Product Change Notification

PCN-FDC-7573-2022

Business Unit	Product Line Code	Type of Change	Action	Date of Issue
FDC - Field Device Connectors	ABQ	Product Change Notification	Notify Distributors and Field	1/7/2022

Previous Product	New Product
<p>Old:</p> 	<p>New:</p>

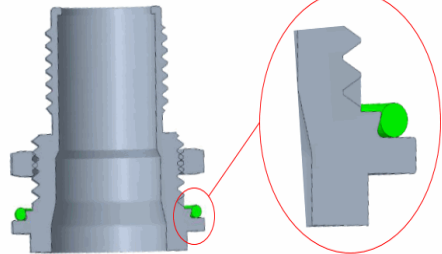
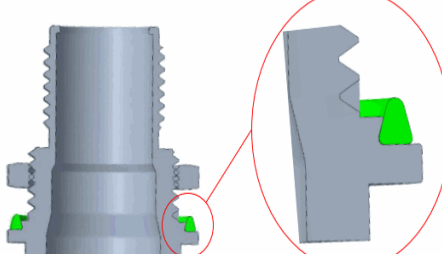
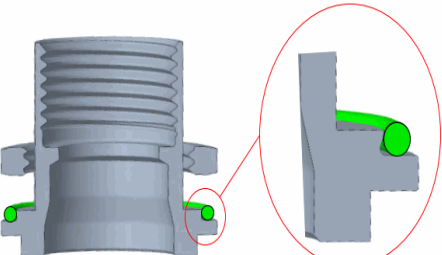
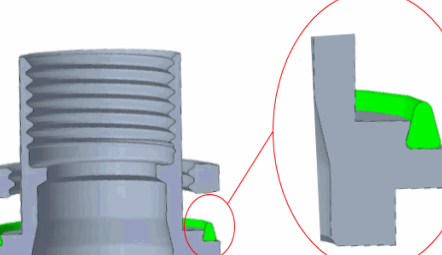
As part of the ongoing improvement process, the geometry of the seal on the housing of the items included in this document is being changed. This will allow an even tighter and better of the seal. The technical and electrical properties of the connectors will remain unchanged.

In future, a molded seal will be used instead of an O-ring. There are no changes to the technical performance data, the approvals, or the external dimensions. When installed, the housing contour will remain unchanged.
